City of Ketchum

Recommendation to hold a public hearing and approve the Lot Line Shift Preliminary Plat and Waiver Request to readjust the lot lines between two existing parcels, 131 Topaz Street and 151 Topaz Street

A PLAT SHOWING GEM STREET SUBDIVISION

Draft Findings of Fact, Conclusions of Law, and Decision

Figure 2.
Proposed Lot
Configuration

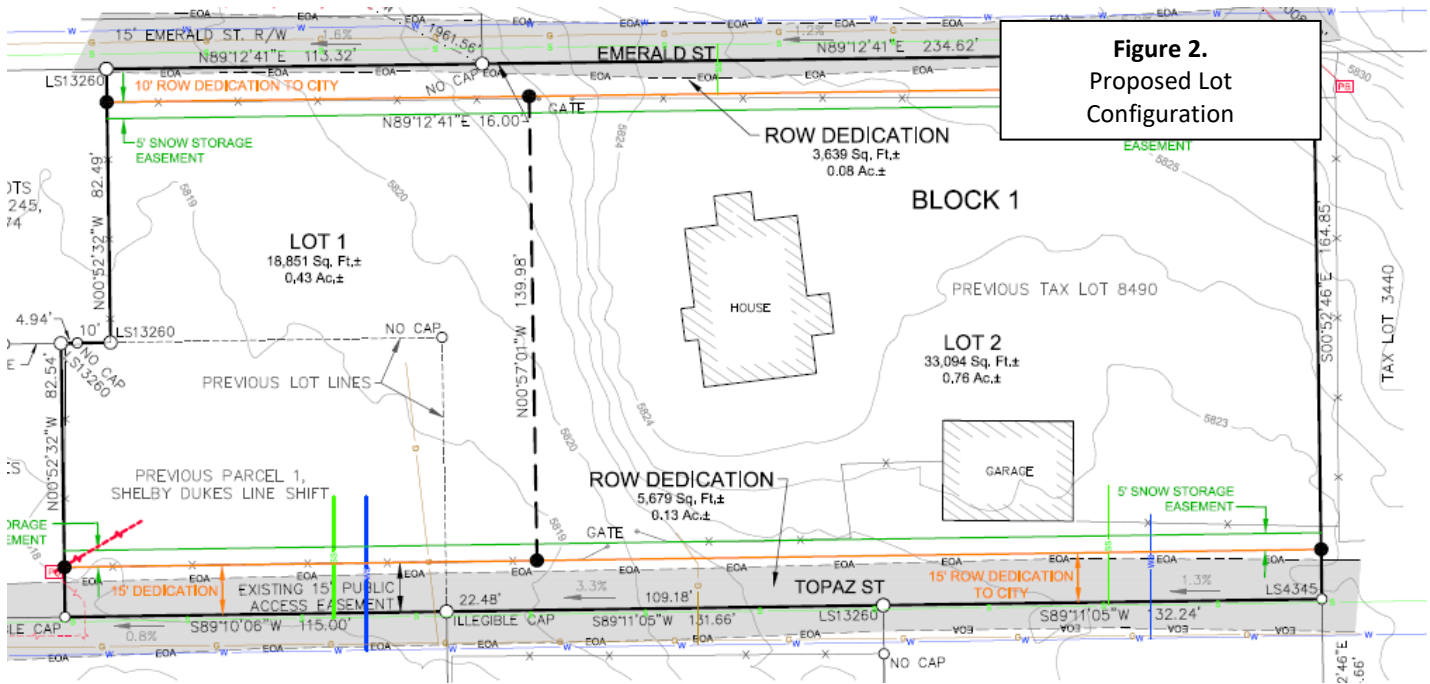
The Lot Line Shift action would reduce 151 Topaz to 0.76 acres in size and enlarge 131 Topaz to 0.43 acres in size. The proposed reconfiguration would also provide dedication of city right-of-way on both Topaz and Emerald Street for the entire lengths of both lots. However, the action as proposed would change 131 Topaz from a single-frontage lot into a double-frontage lot. The subdivision code prohibits the creation of new “double-frontage” lots and the property owners have requested a waiver from this standard.

City staff support granting the waiver request as part of this action because of the dedication of right-of-way to the city. See Figure 2 (next page) for the proposed right-of-way dedication. Additional analysis related to the waiver request is contained in Attachment D, Draft Findings of Fact, Conclusions of Law, and Decision.

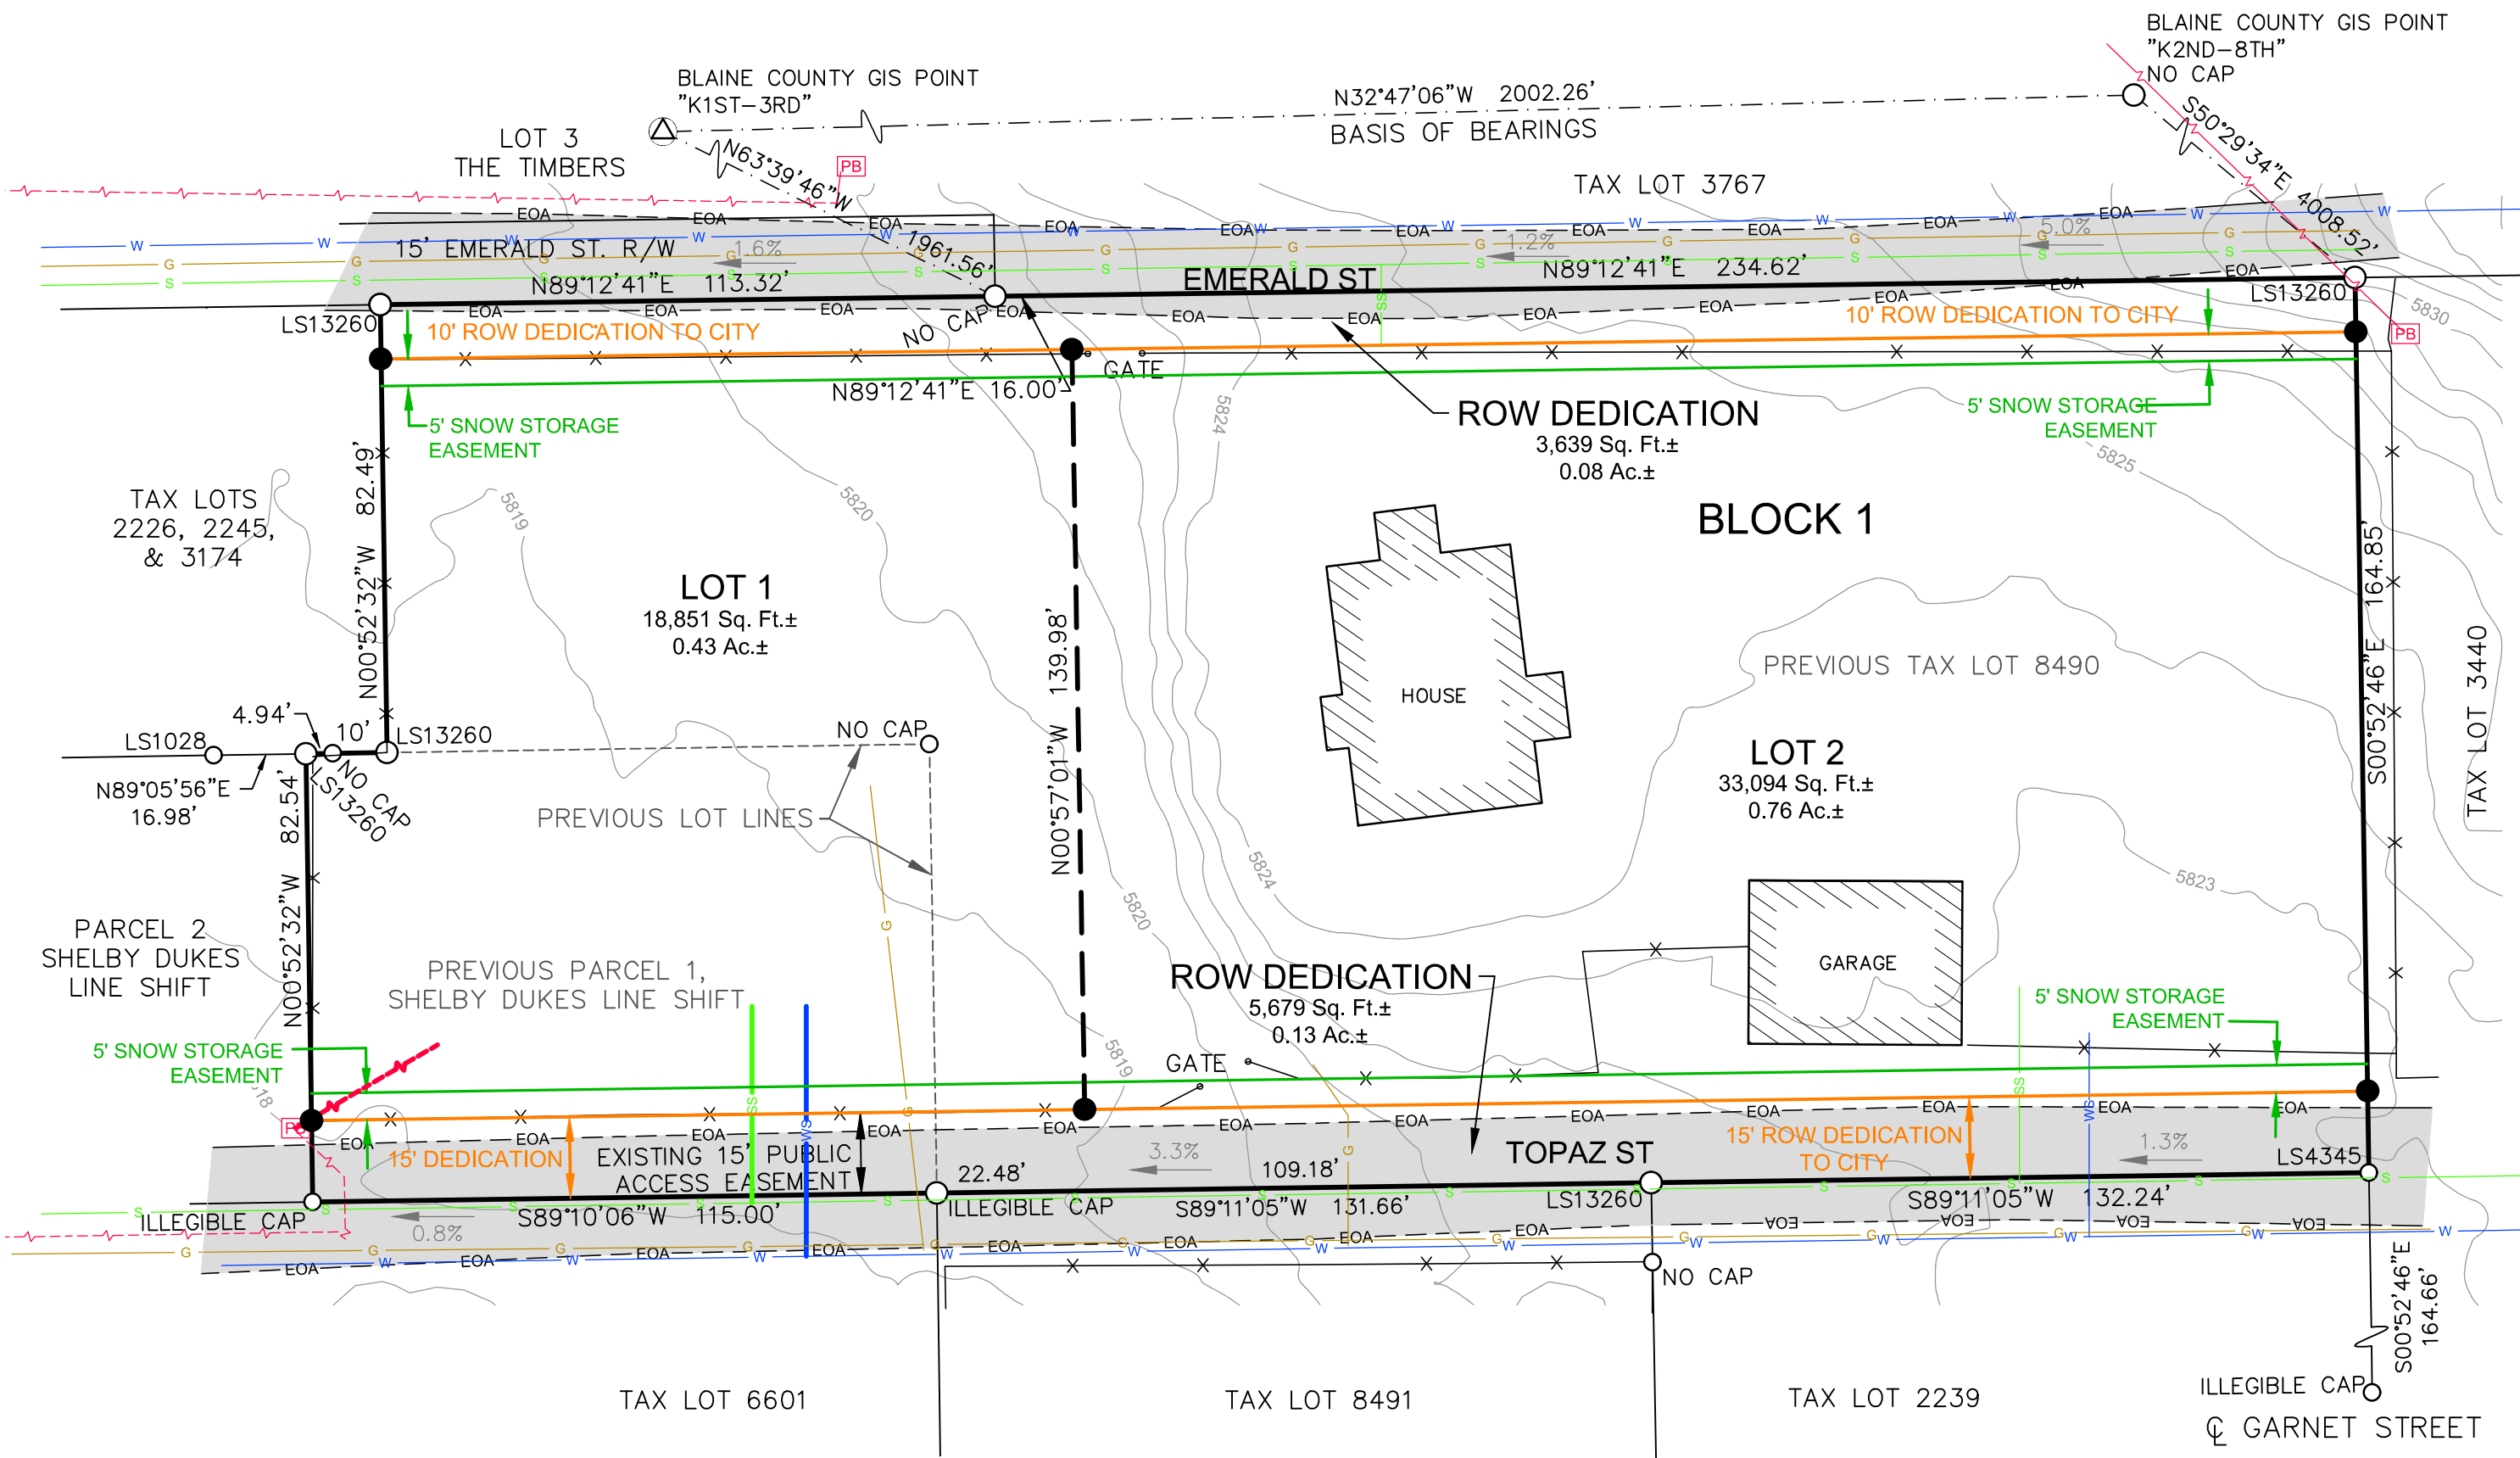
X	<input type="checkbox"/>	<input type="checkbox"/>	16.04.030. J.7	The scaled location of existing buildings, water bodies and courses and location of the adjoining or immediately adjacent dedicated streets, roadways and easements, public and private.
			Findings	Present
X	<input type="checkbox"/>	<input type="checkbox"/>	16.04.030.J .8	Boundary description and the area of the tract.
			Findings	Present
X	<input type="checkbox"/>	<input type="checkbox"/>	16.04.030.J.9	Existing zoning of the tract.
			Findings	Present
X	<input type="checkbox"/>	<input type="checkbox"/>	16.04.030.J.10	The proposed location of street rights of way, lots, and lot lines, easements, including all approximate dimensions, and including all proposed lot and block numbering and proposed street names.
			Findings	<ul style="list-style-type: none"> • The Plat includes a 15' dedication of right-of-way on Topaz street, with a 5' snow storage easement located parallel to the front property line. • The Plat indicates a 10' dedication of right-of-way on Emerald Street, with a 5' snow storage easement located parallel to the front property line.

Findings	<p>Re: #5, 151 Topaz is an existing, non-conforming double-frontage lot. This Readjustment of Lot Lines would create an additional double frontage lot (131 Topaz), which is not permitted. However, the applicant has submitted a Waiver Request consistent with the requirements of Title 16 to request a waiver from this standard. The Commission recommended approval of the waiver request.</p> <p>#2, 3, 4 are N/A.</p> <p>Standards #1, and #6 have been met.</p>
<input type="checkbox"/>	<input type="checkbox"/>	X	16.04.040.G	<p>G. Block Requirements: The length, width and shape of blocks within a proposed subdivision shall conform to the following requirements:</p> <ol style="list-style-type: none"> 1. No block shall be longer than one thousand two hundred feet (1,200'), nor less than four hundred feet (400') between the street intersections, and shall have sufficient depth to provide for two (2) tiers of lots. 2. Blocks shall be laid out in such a manner as to comply with the lot requirements. 3. The layout of blocks shall take into consideration the natural topography of the land to promote access within the subdivision and minimize cuts and fills for roads and minimize adverse impact on environment, watercourses and topographical features. 4. Except in the original Ketchum Townsite, corner lots shall contain a building envelope outside of a seventy five foot (75') radius from the intersection of the streets.

Findings	<p>151 Topaz is connected to municipal sewer.</p> <p>131 Topaz is not currently connected to municipal sewer but because it is an existing lot and this action is a readjustment of existing lot lines connection is not required at this time.</p>
X	<input type="checkbox"/>	<input type="checkbox"/>	16.04.040.L	<p>L. Water System Improvements: A central domestic water distribution system shall be installed in all subdivisions by the subdivider as a required improvement. The subdivider shall also be required to locate and install an adequate number of fire hydrants within the proposed subdivision according to specifications and requirements of the City under the supervision of the Ketchum Fire Department and other regulatory agencies having jurisdiction. Furthermore, the central water system shall have sufficient flow for domestic use and adequate fire flow. All such water systems installed shall be looped extensions, and no dead end systems shall be permitted. All water systems shall be connected to the Municipal water system and shall meet the standards of the following agencies: Idaho Department of Public Health, Idaho Survey and Rating Bureau, District Sanitarian, Idaho State Public Utilities Commission, Idaho Department of Reclamation, and all requirements of the City.</p>

Findings	<p>151 Topaz is connected to municipal water.</p> <p>131 Topaz is not currently connected to municipal water but because it is an existing lot and this action is a readjustment of existing lot lines connection is not required at this time.</p>
<input type="checkbox"/>	<input type="checkbox"/>	X	16.04.040.M	<p>M. Planting Strip Improvements: Planting strips shall be required improvements. When a predominantly residential subdivision is proposed for land adjoining incompatible uses or features such as highways, railroads, commercial or light industrial districts or off street parking areas, the subdivider shall provide planting strips to screen the view of such incompatible features. The subdivider shall submit a landscaping plan for such planting strip with the preliminary plat application, and the landscaping shall be a required improvement.</p>
			Findings	<p>N/A, this is readjustment of lot lines of existing lots and none of the conditions described by this standards are applicable.</p>

1. An indemnification agreement, indemnifying the city for damages to the existing fences located on both lots, shall be recorded prior to recording the Final Plat and the instrument number for the Agreement shall be indicated on the Final Plat; and

3. The recorded plat shall show a minimum of two Blaine County Survey Control Monuments with ties to the property and an inverse between the two monuments. The Survey Control Monuments shall be clearly identified on the face of the map; and
